PRODUCT ADVISORY

Data Sheet Specification Correction for Intersil Product TW2960-LA1-CR

**Refer to:
PA12075**

Date: September 18, 2012

Old POD Q100.12x12A - PA12075

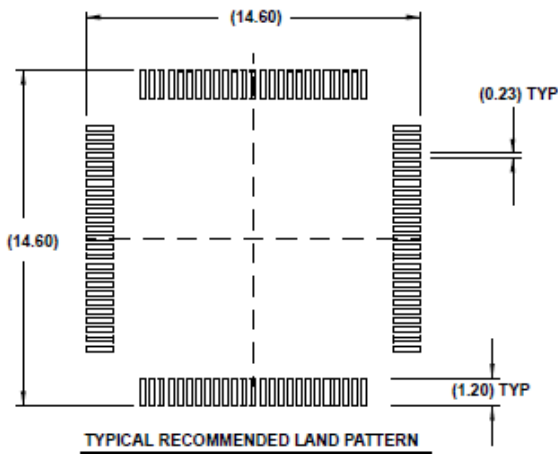
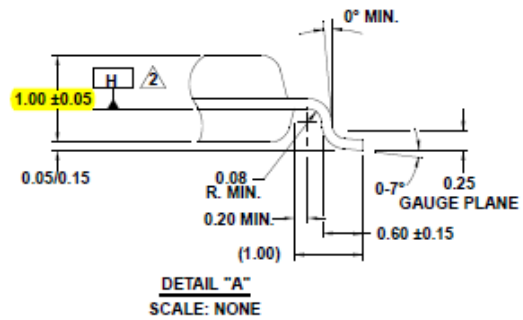
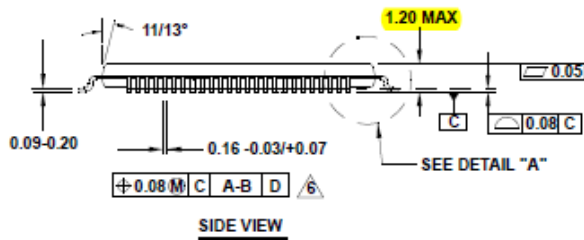
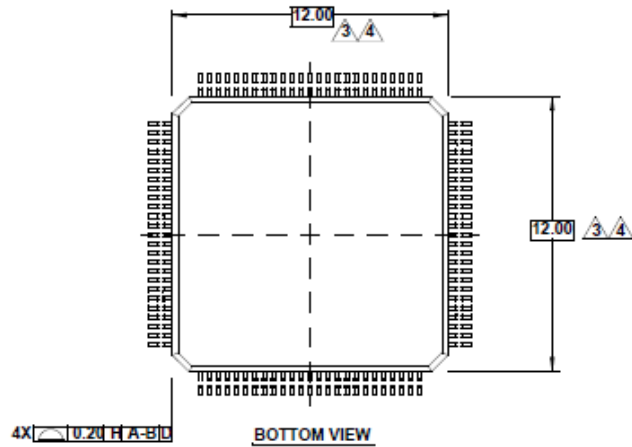
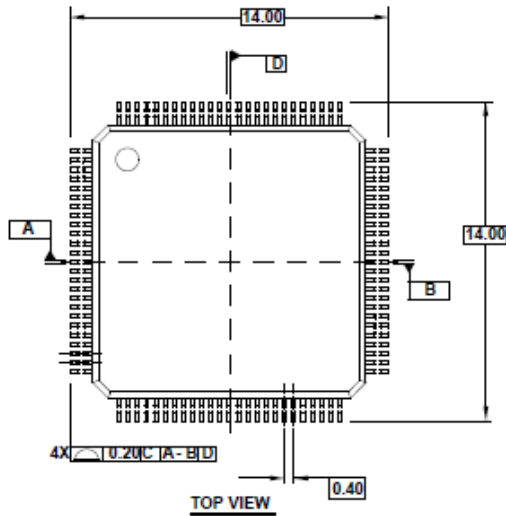
This advisory is to inform you that Intersil has made corrections to the POD (Package Outline Drawing) referenced in the data sheet specification for product TW2960-LA1-CR. The updates to the POD correct the thickness (height) of the package body. The old and new PODs are contained on following pages. There have been no changes to the package or product itself. The updated data sheet is available upon request.
